Change Order

PROJECT: *(Name and address)*
Mansfield ISD 2024 Bond Program - A2
Summit High School
Baseball/Softball/Turf & Batting Cages
1071 Turner Warnell Road
Arlington, Texas 7601

Prime Contract Change Order #09: CE #009 - RFP#04 - Batting Cage & Bullpen Relocation

RFP #4

CONCRETE RETAINING WALL

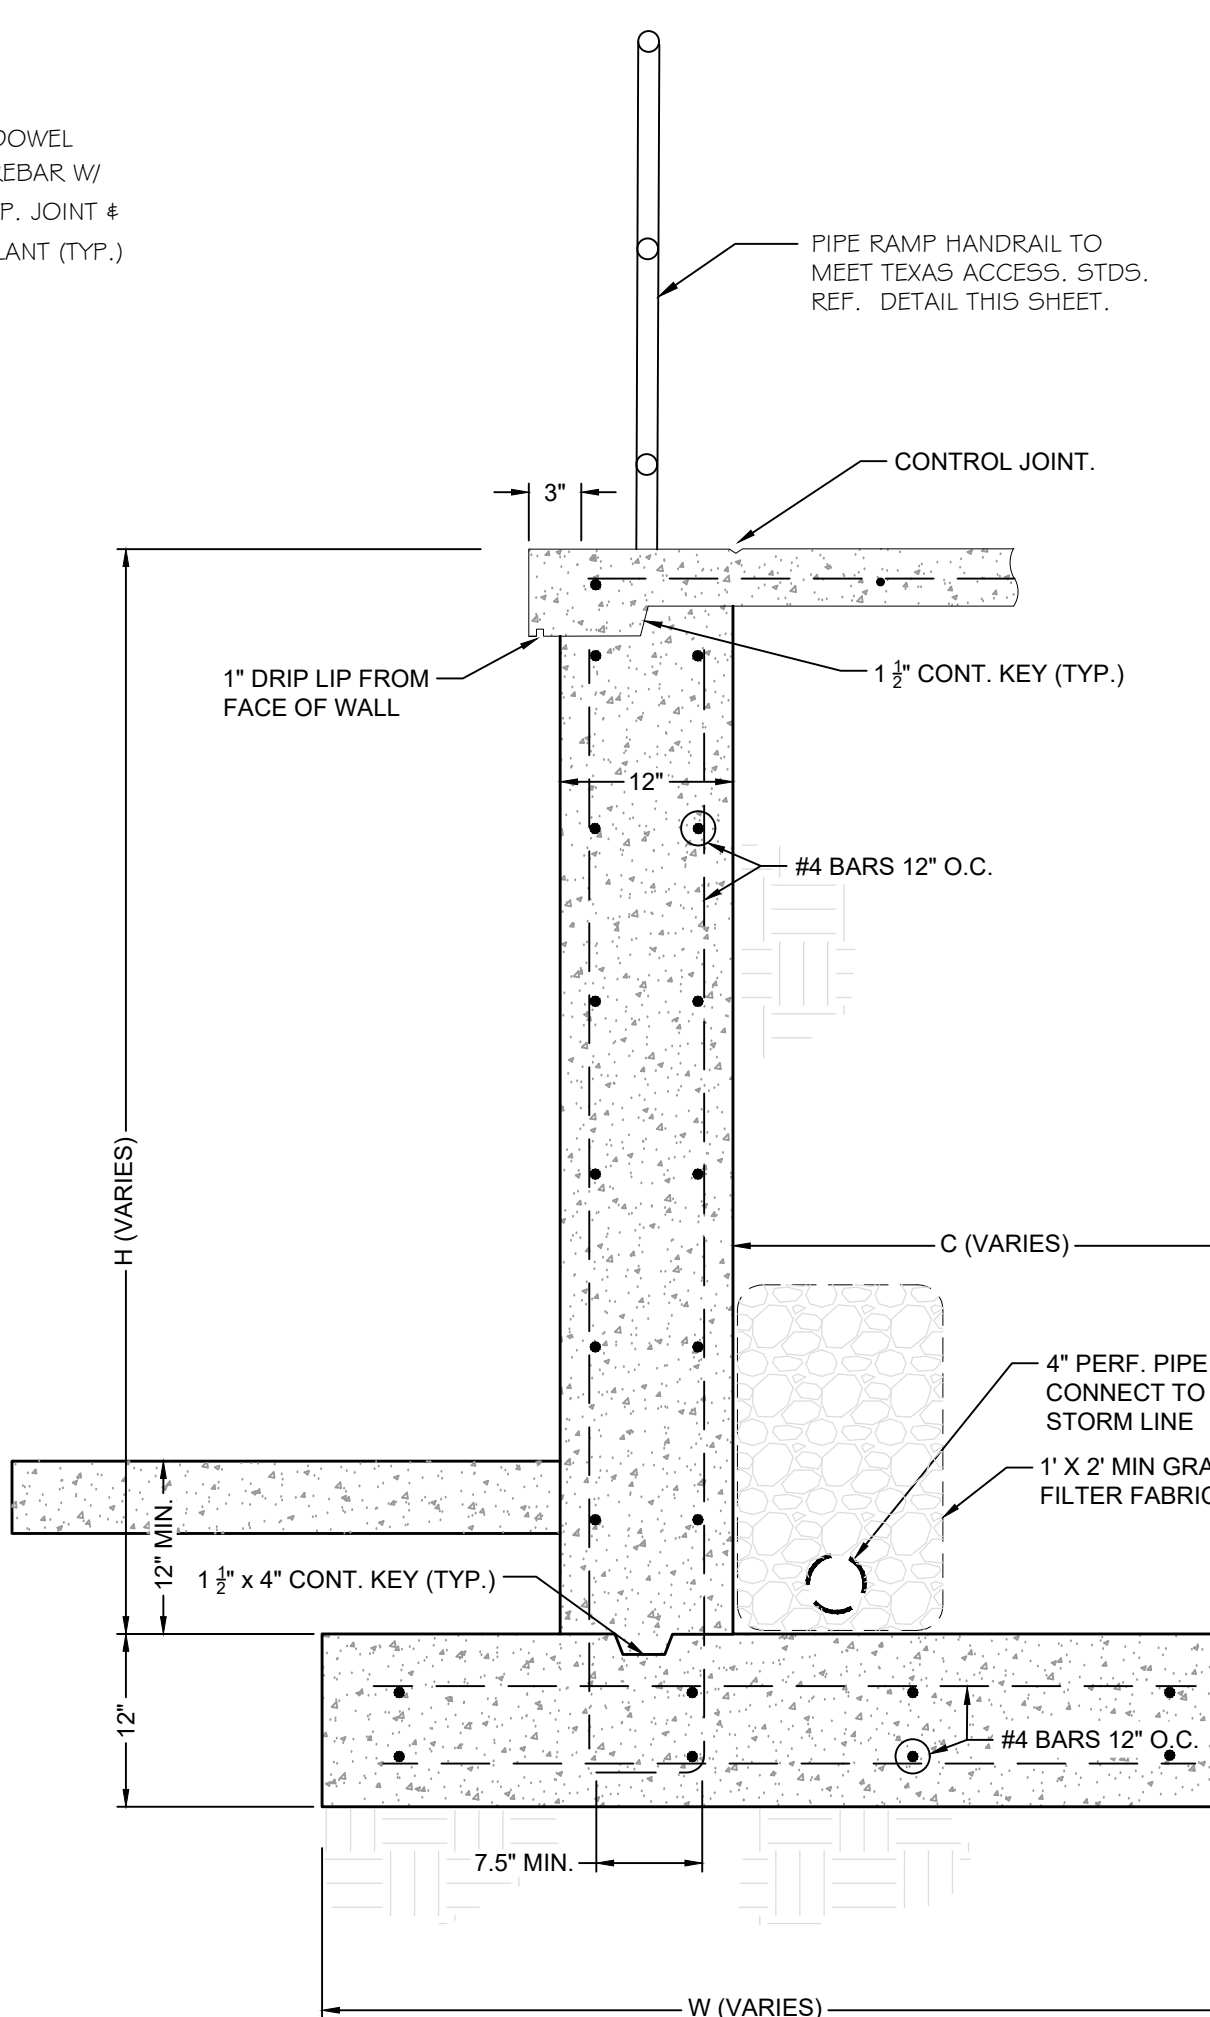
Description of Change: Add 152 Lft of Retainage wall railing per C3.00 Detail "Concrete retaining wall C6.03"

1. PSC will excavate footing for new retaining wall the borders the baseball field approximately 195 LF.
2. PSC will form and pour new concrete retaining wall approximately 195 LF as shown on sheet C4.0 and per detail on sheet C6.03.
3. PSC will install a 4" HDPE N-12 perforated pipe behind the wall with drain stone wrapped in fabric. PSC will tie the 4" pipe into the nearest storm drain.
4. Note: retaining walls not bordering the baseball field are excluded, all flatwork, ramps, and handrails excluded.
5. Performance and payment bonds excluded.

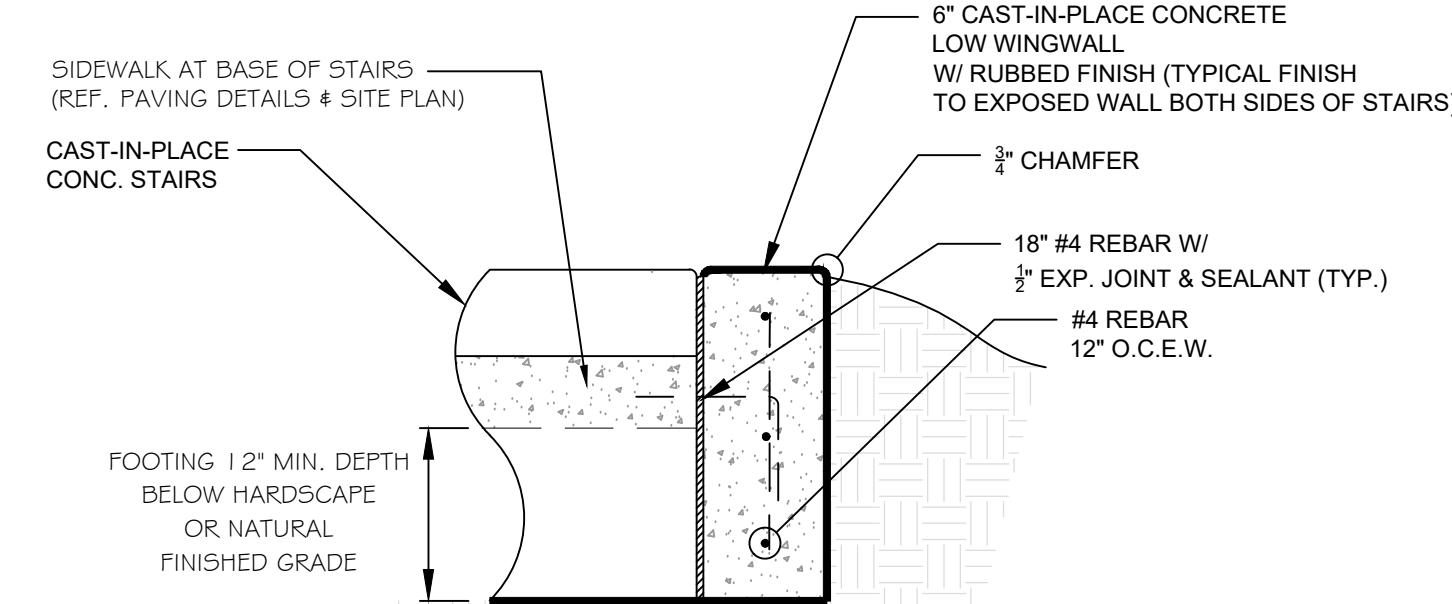
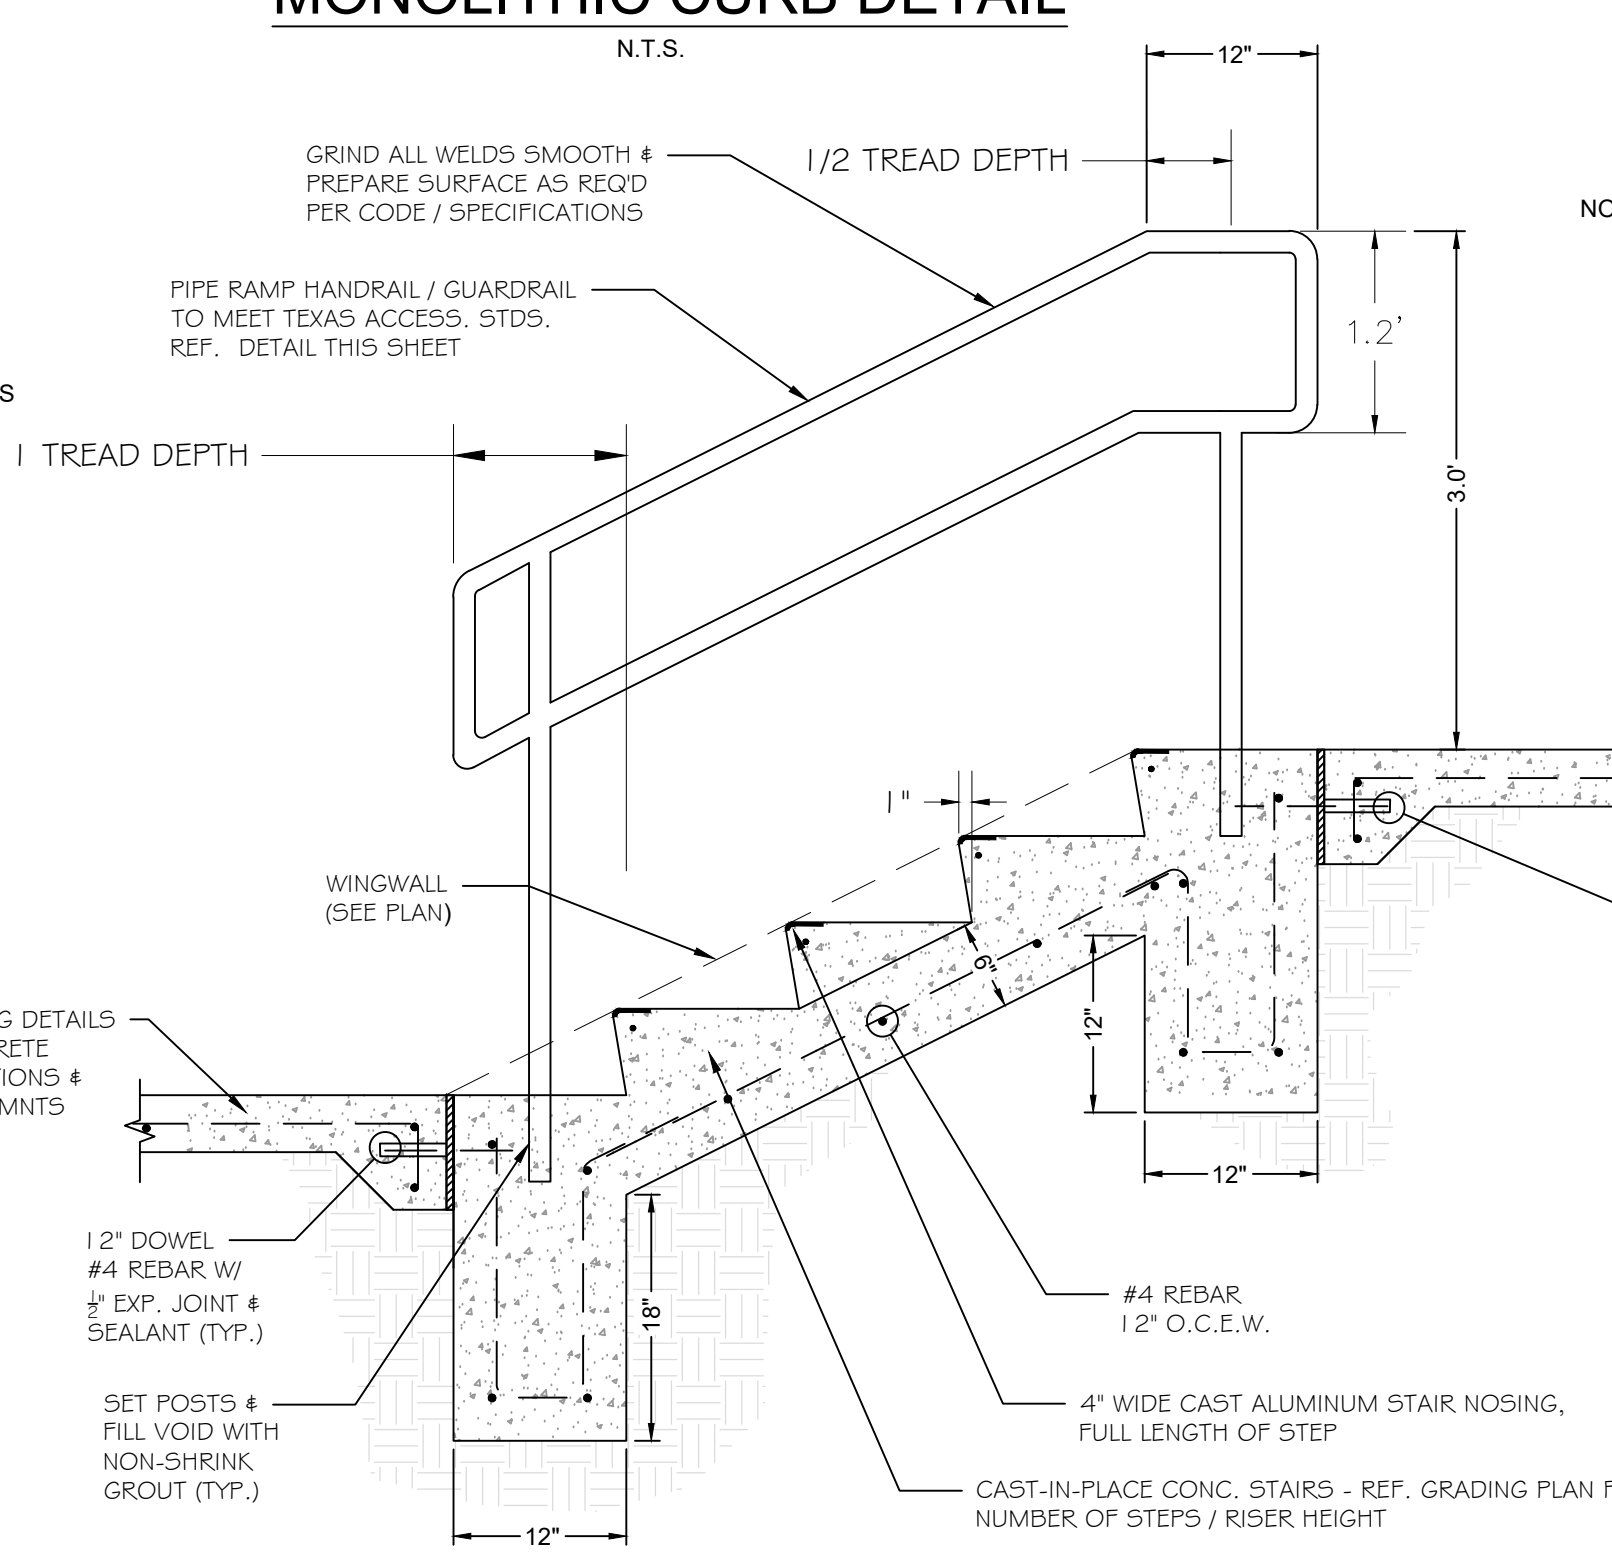
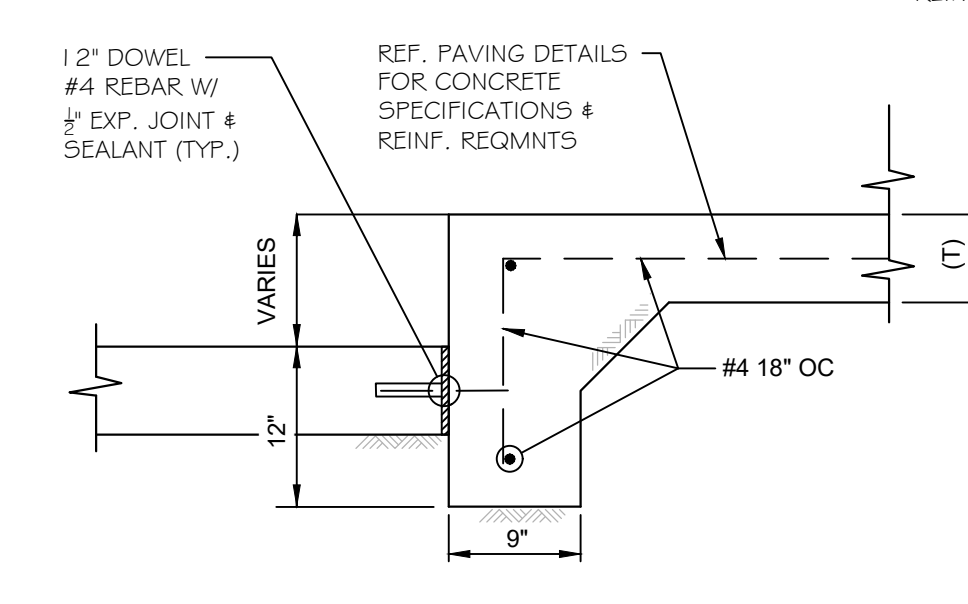
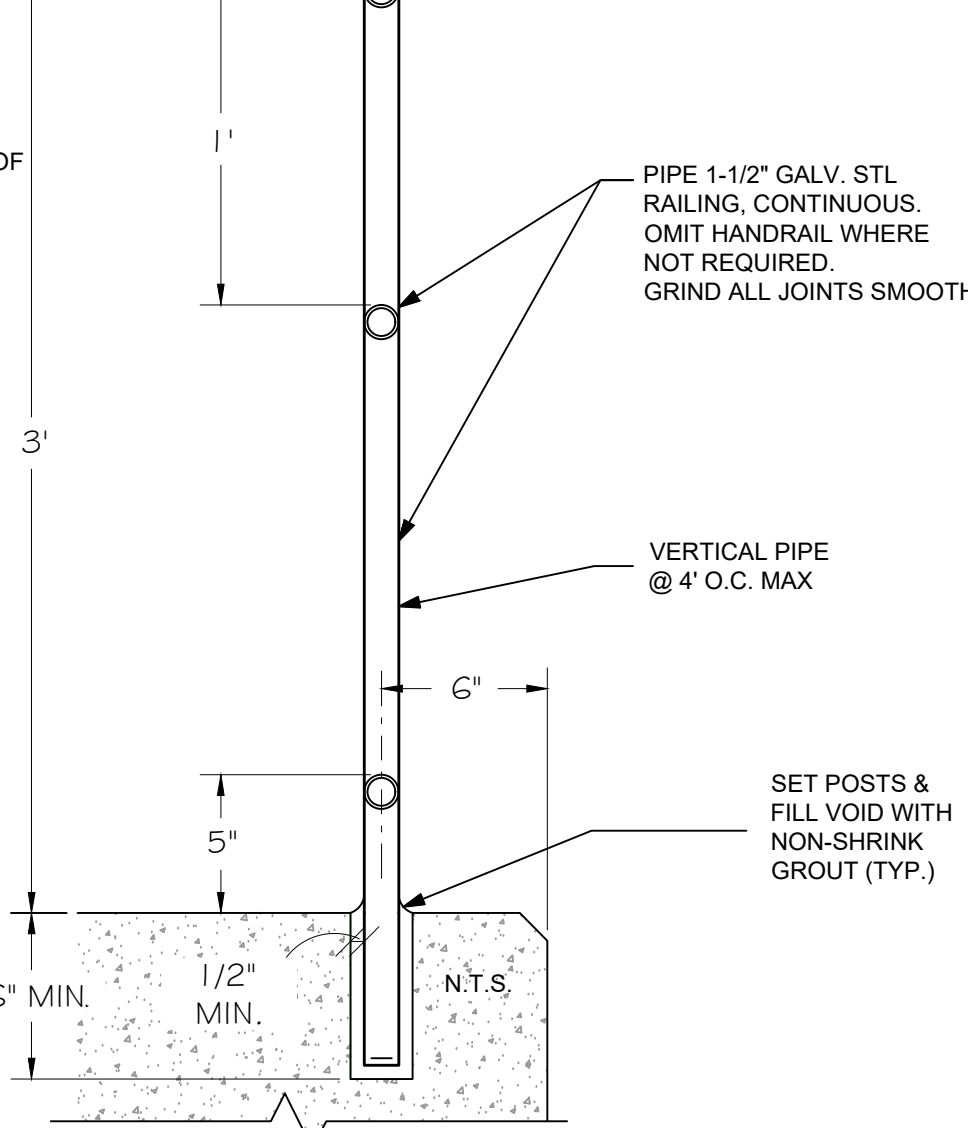
1) ADDED TYPICAL STAIR, TYPICAL WING WALL, CONCRETE RETAINING WALL, THICKENED PAVEMENT EDGE, AND HAND RAIL DETAILS
